SHELDON HIGH SCHOOL ROOFING 2020
C.I.P. No. 420.652.209

ROBERTSON/SHERWOOD/ARCHITECTS pc
132 E. Broadway - Suite 540
Eugene, Oregon
Project No. 1901

This Addendum forms a part of the Contract Documents and modifies the original Bid Documents dated February 24, 2020 and Addendum No. 1 dated March 4, 2020 as noted below. Acknowledge receipt of this Addendum in the space provided on the Bid Form. Failure to do so may subject Bidder to disqualification.

A1 ROOF PLAN - SOUTHWEST
 104 1/16" = 1'-0"

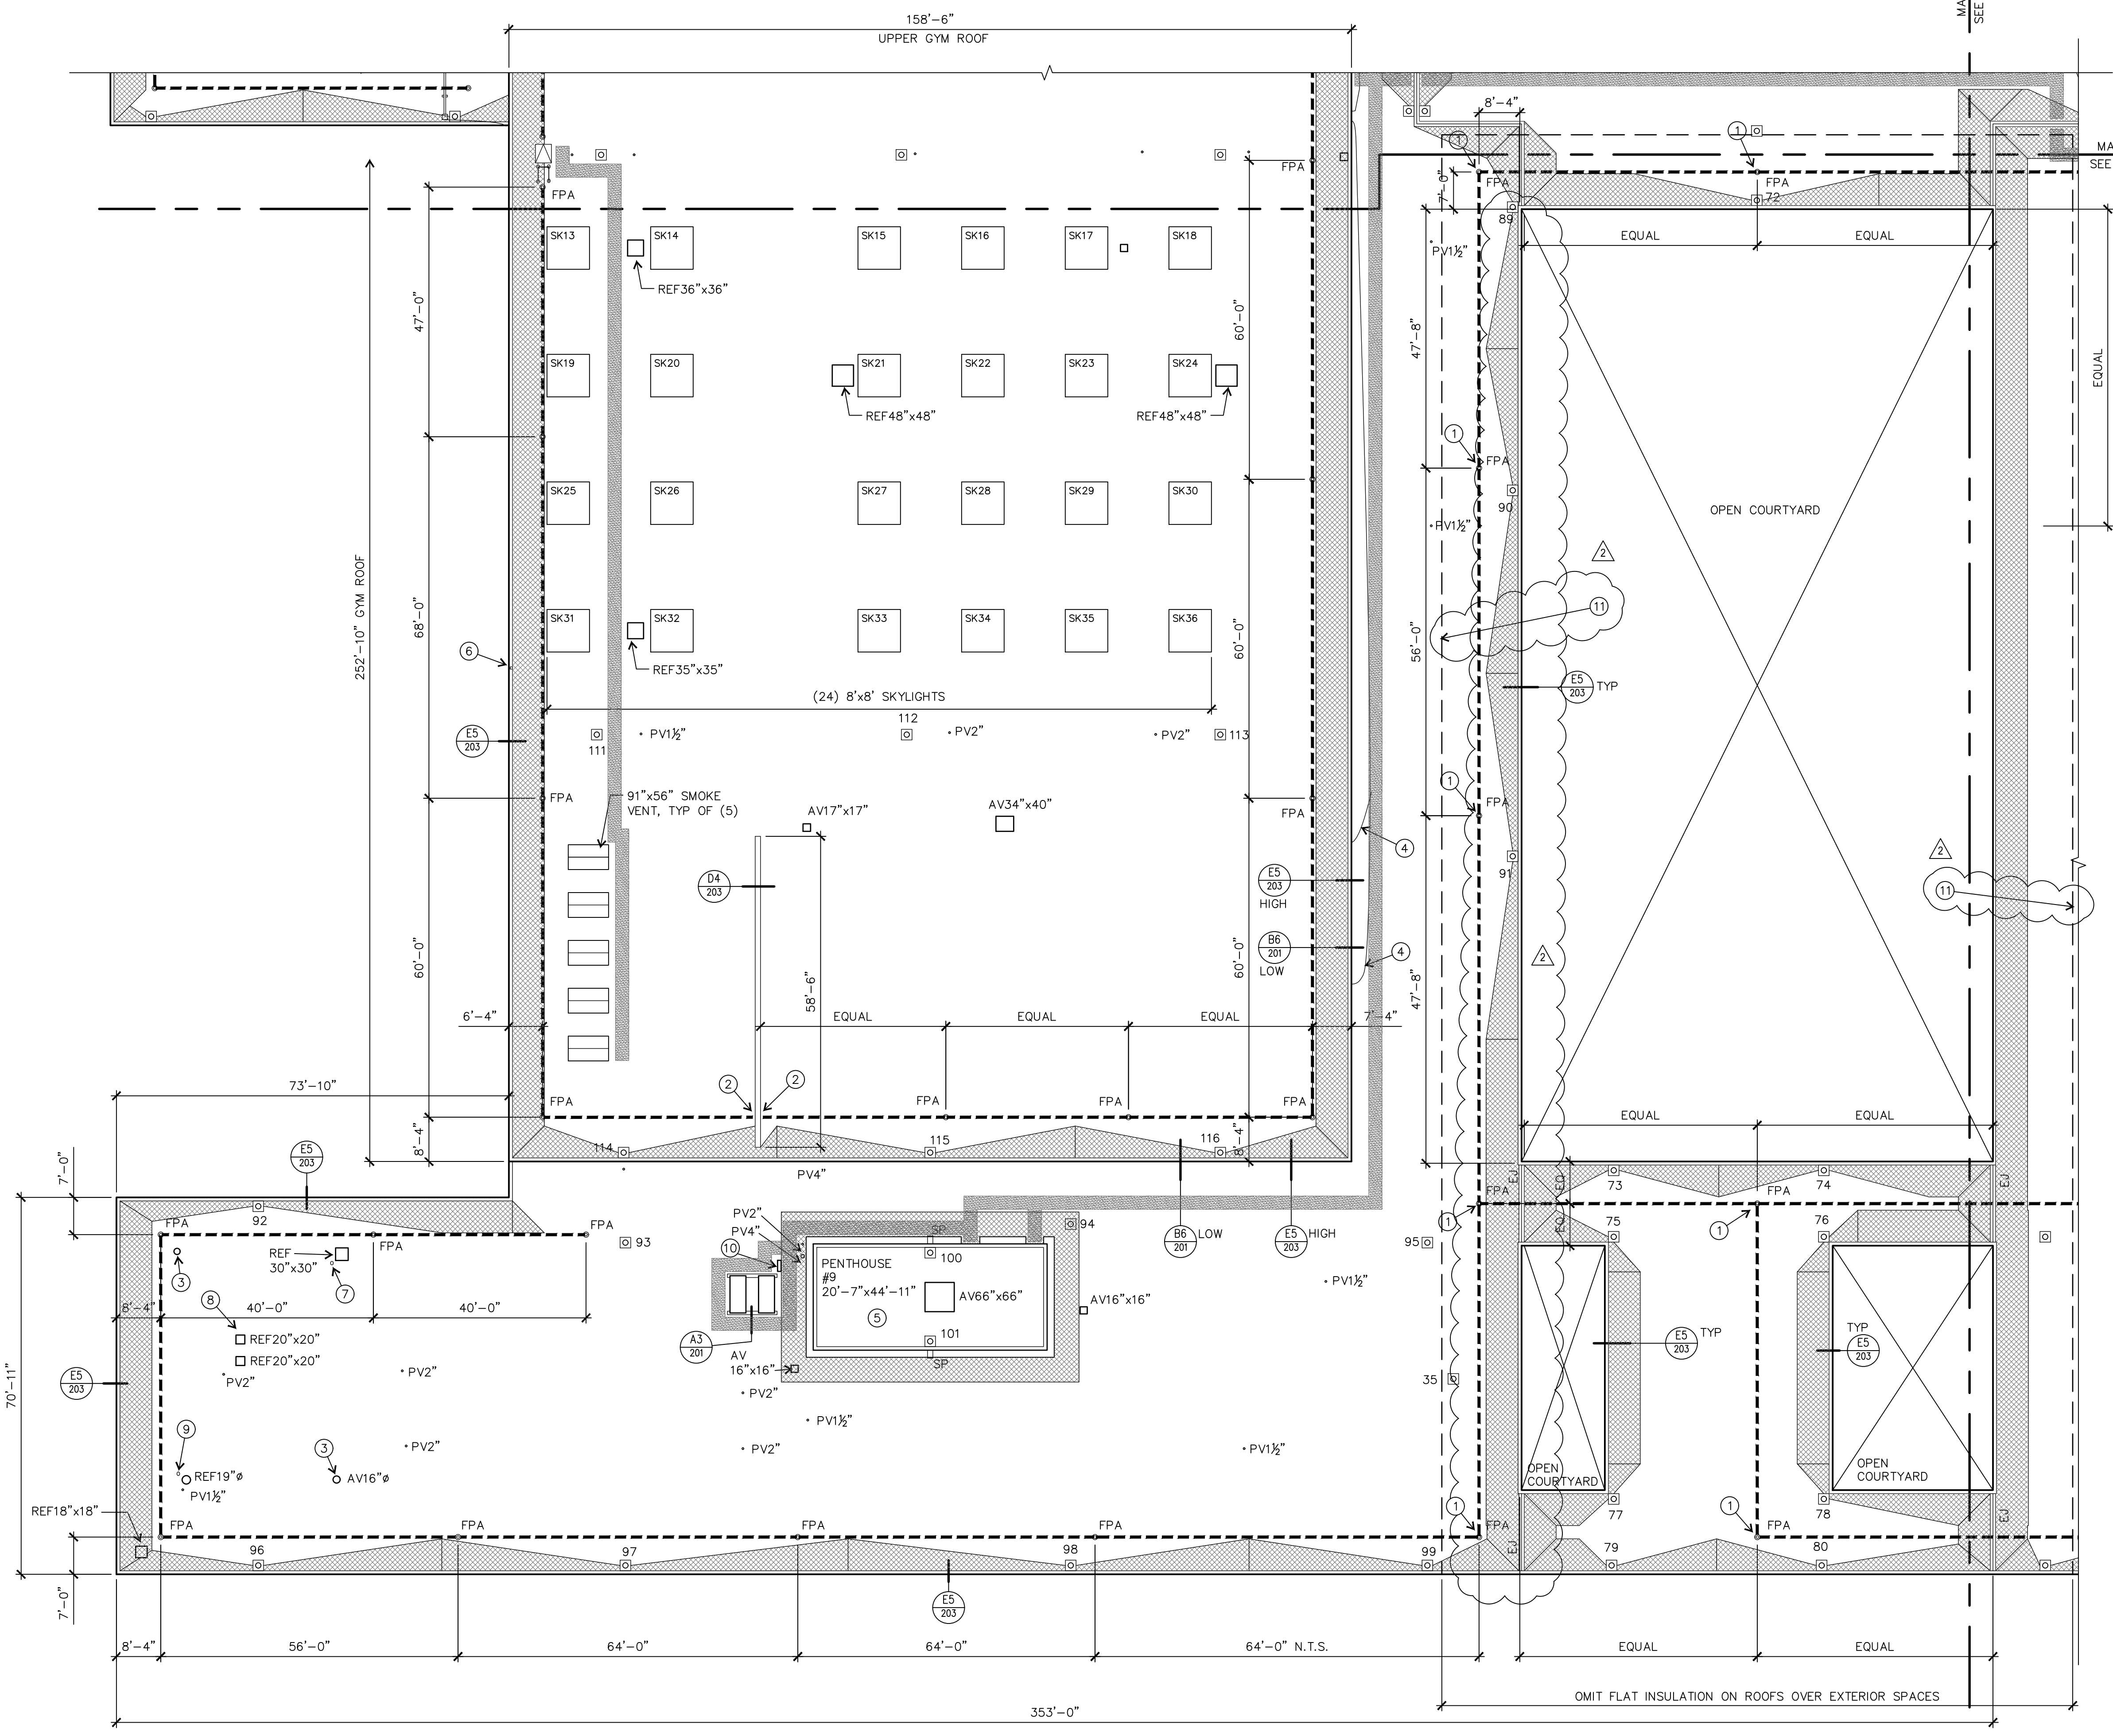
7. DRAWING SHEET 104

A. Replace Drawing Sheet 104 with new Drawing Sheet attached to this Addendum.

- i) Clarification:
 - (a) Keyed Note 11 is added to more clearly define where flat insulation transitions to courtyard roofs without flat insulation.
 - (b) Hatch pattern is added to triangular tapered insulation areas at west side of open courtyards.

- 1 PLASTER CEILING / NO ACCESS FROM BELOW; INSTALL FALL PROTECTION ANCHOR PER C1/202
- 2 WALL ANCHOR AT (E) CONC WALL E4/203
- 3 (E) 16" AV E1/201
- 4 LOOSE COMMUNICATIONS CABLE PENETRATING CNTRFLASHG & (E) LOUVER
- 5 SEE A1/101 FOR TYPICAL PENTHOUSE ROOF PLAN
- 6 REINSTALL (E) PHOTOCELL ON NEW SM FASCIA
- 7 PROVIDE LIQUID FLASHING AT (E) CONDUIT PENETRATION; REPLACE (E) OUTLET W/ GFCI OUTLET
- 8 (E) CONDUIT PENETRATION THRU CURB A3/203; REPLACE (E) OUTLET W/ GFCI OUTLET
- 9 PROVIDE LIQUID FLASHING AT (E) CONDUIT PENETRATION
- 10 EQUIPMENT CURB B4/203
- 11 LINE OF EXTERIOR WALL OF CONDITIONED SPACE BELOW WHERE FLAT INSULATION ENDS; PROVIDE TAPERED EDGE STRIPS TO TRANSITION FROM FLAT INSULATION TO ROOF WITH NO FLAT INSULATION
